Re: 339 West Gorham Street: Oliv Madison

Attached is a minor amendment packet for the Oliv Madison Project. These changes address some program elements (expanded amenity), design refinements, and adding solar to the project. The packet illustrates the changes between the Original SIP document and the proposed amendments. The site plan review/building permit set elevations are also included for reference to show what was approved with the building permit.

UDC MINOR REVISIONS

ōliv MADISON 339 W GORHAM STREET

JOHNSON STREET

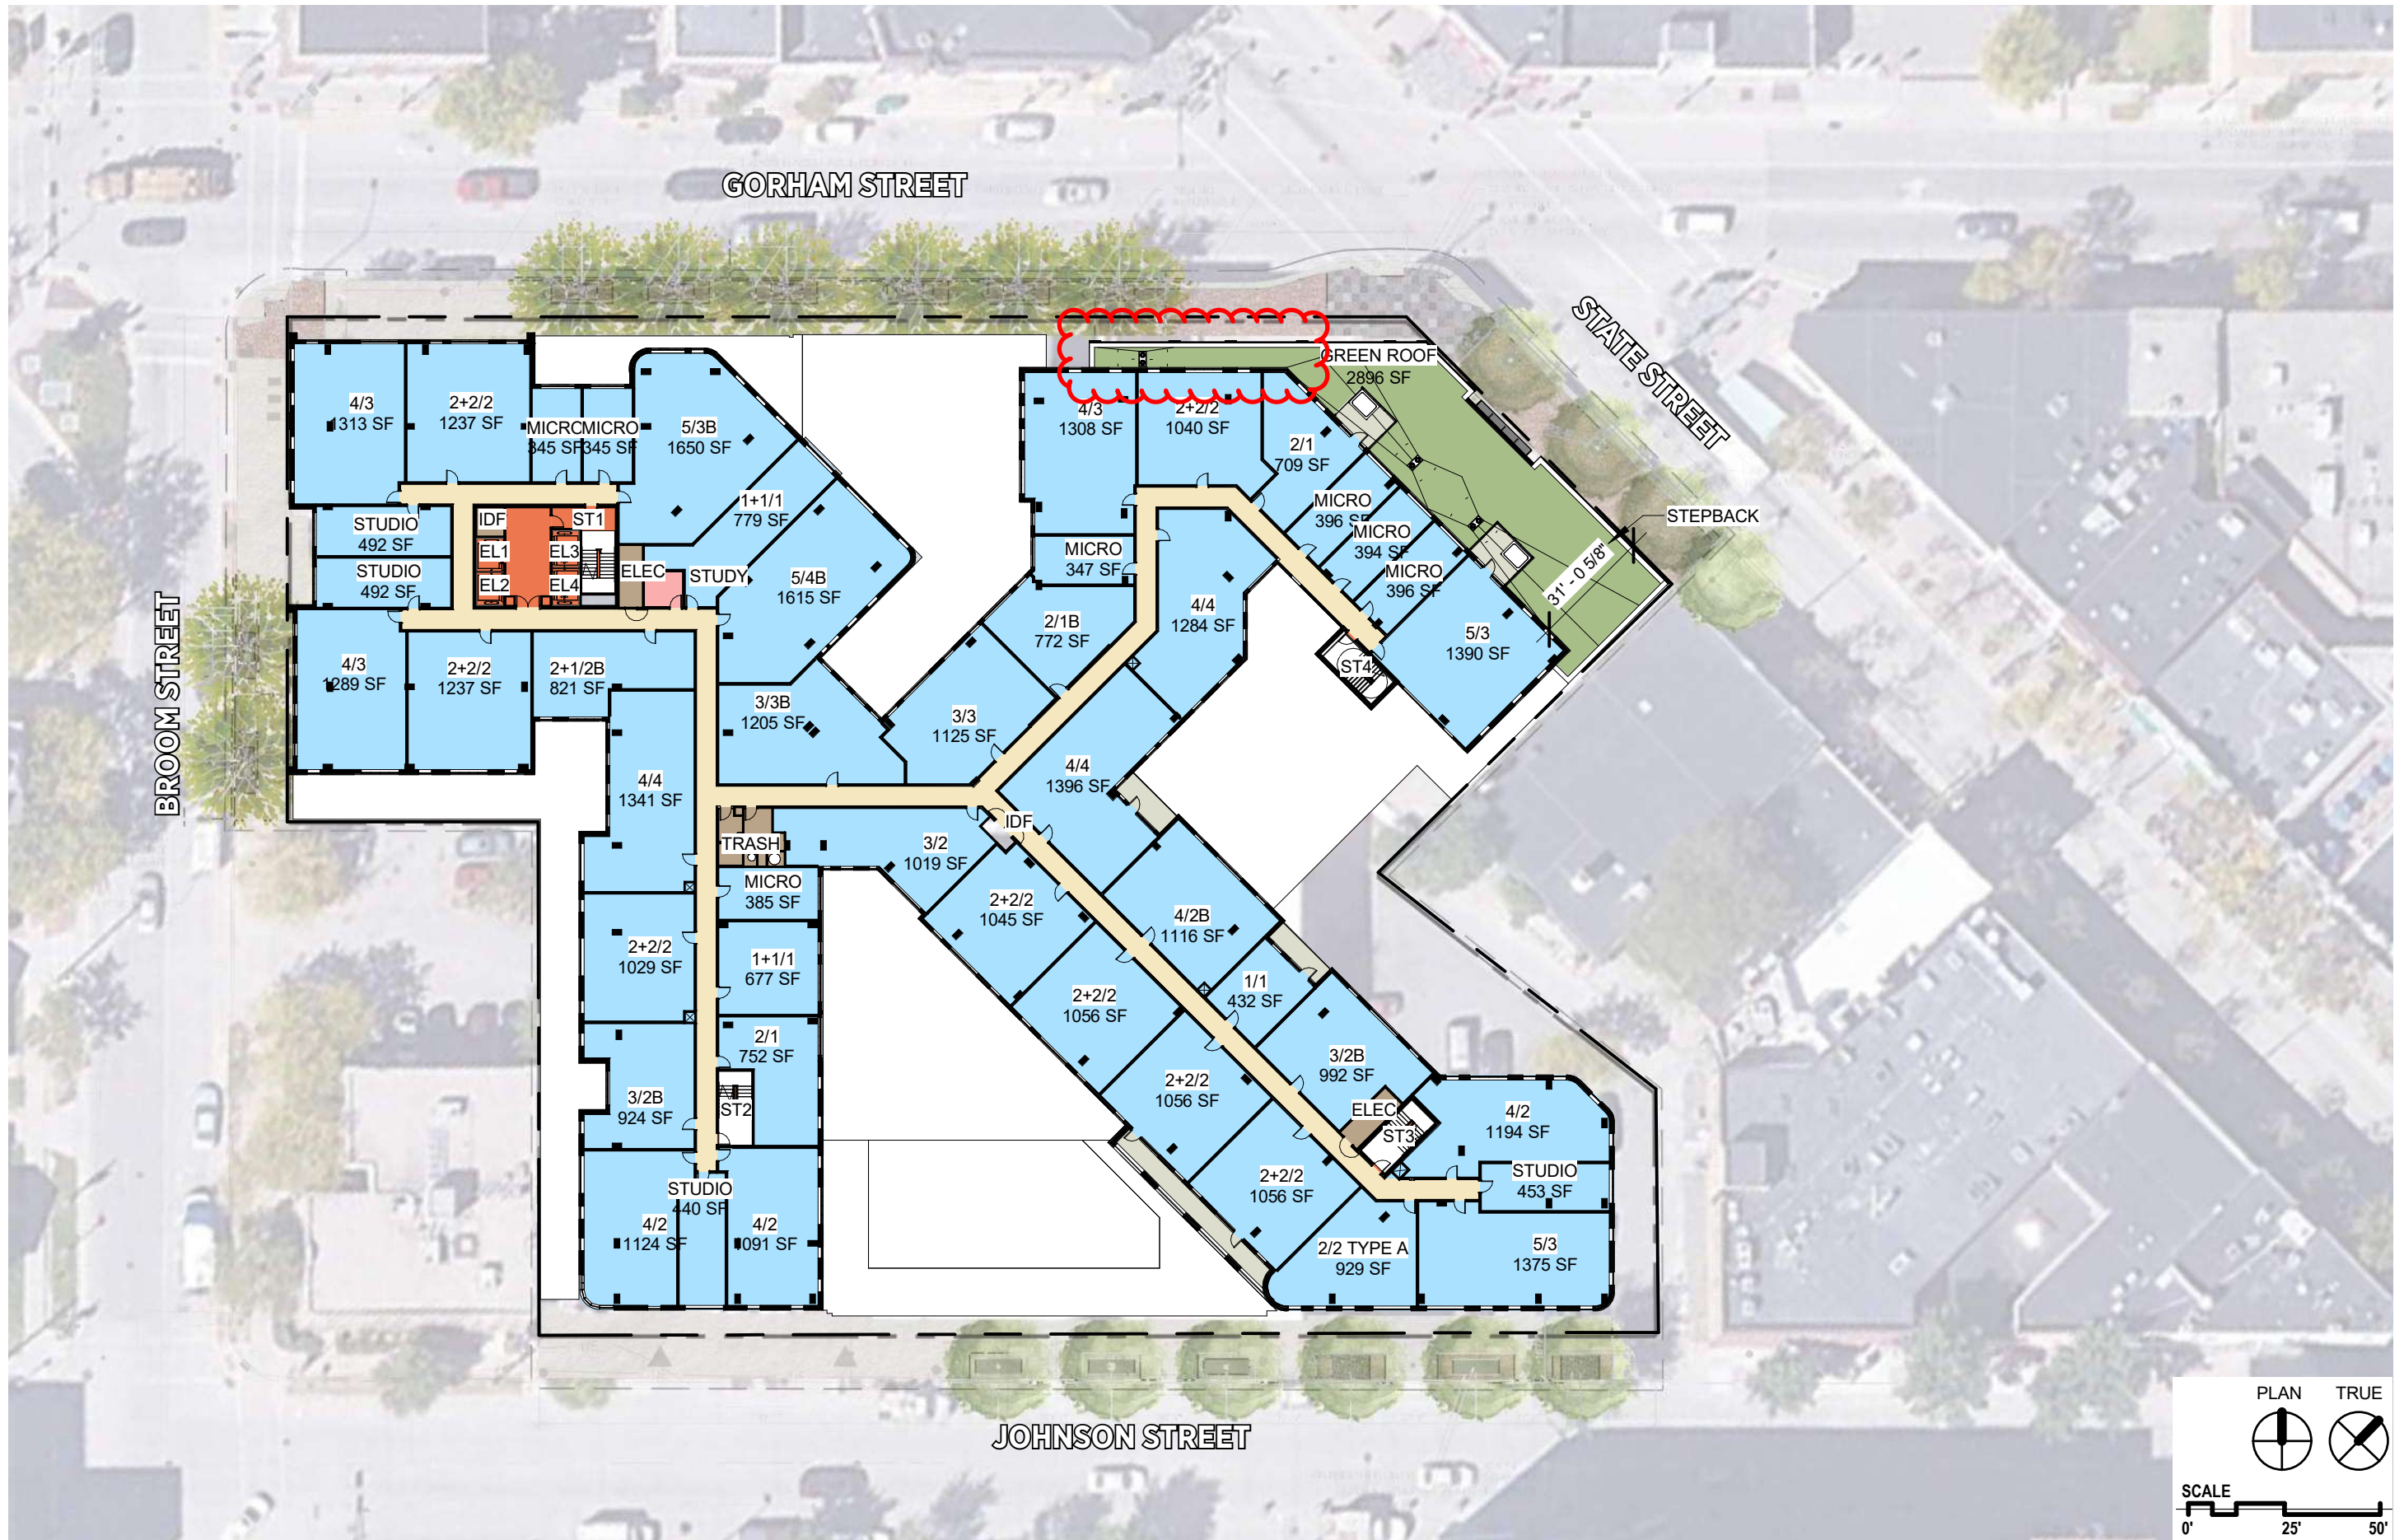
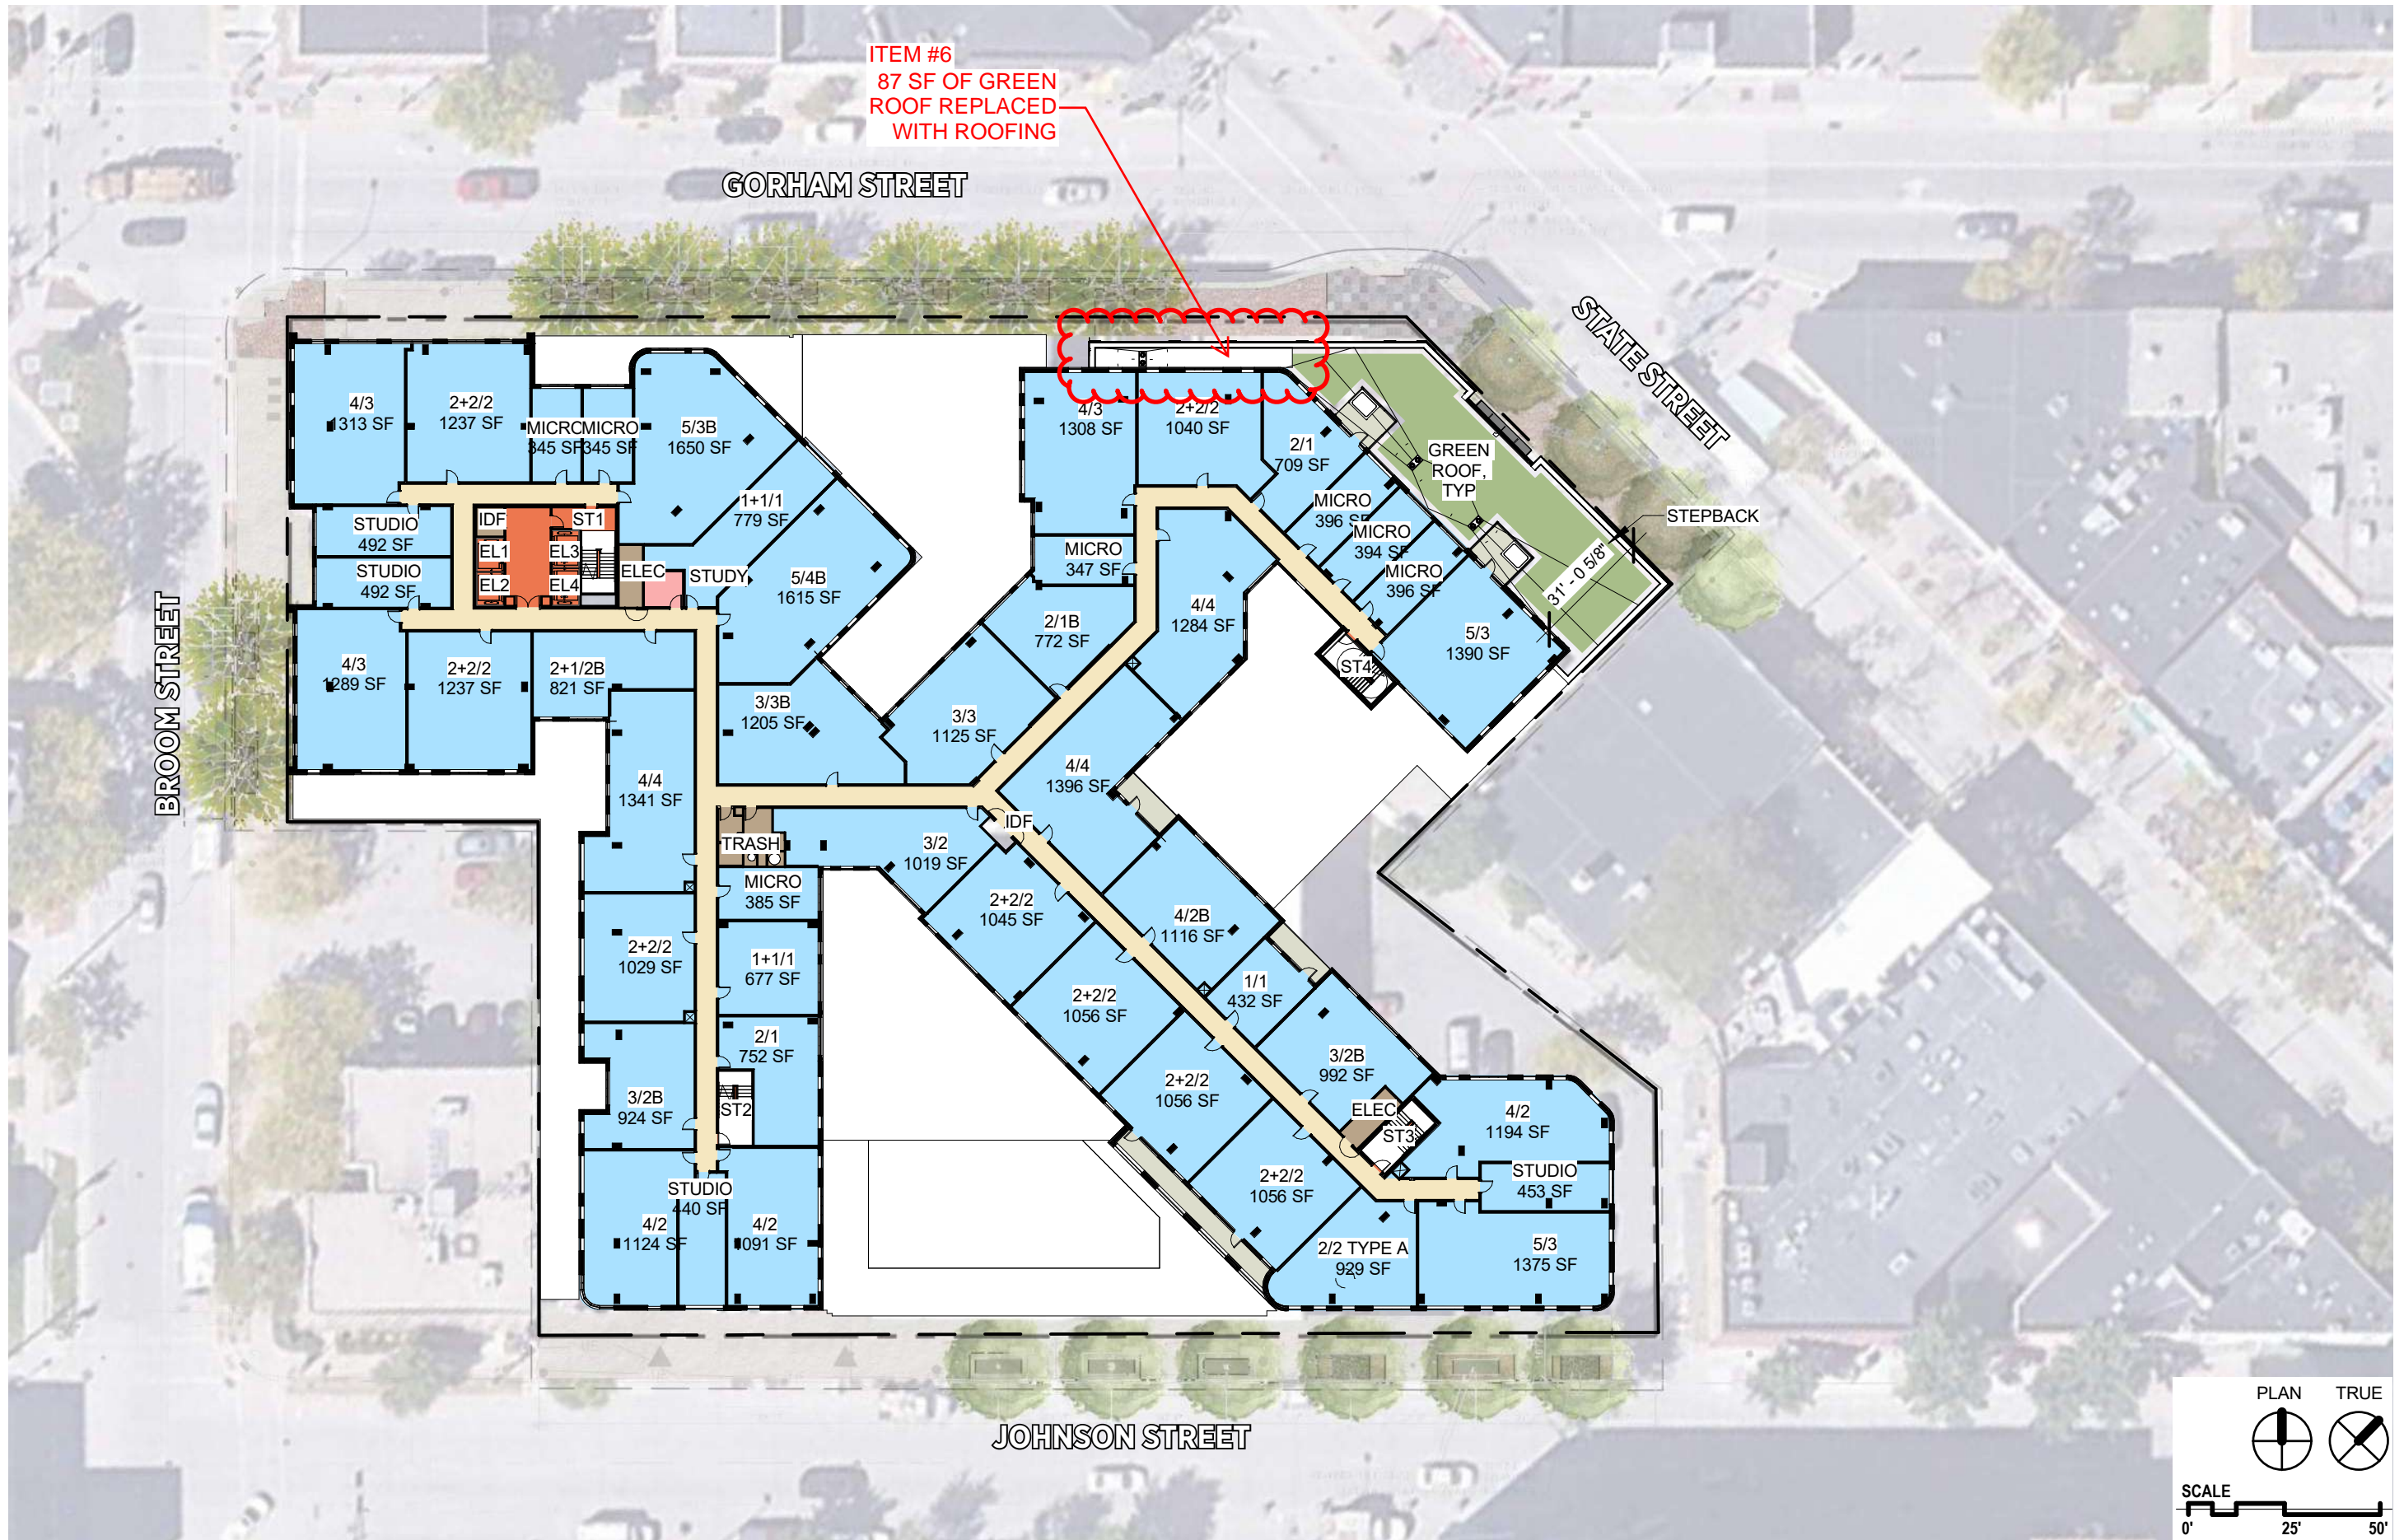
ITEM #5
FITNESS SPACE
EXPANSION

ITEM #5
PROPOSED: 5 BED/ 4 BATH
PREVIOUS: 4 BED /3 BATH

TOTAL BEDS: 1099
PREV. BEDS: 1102
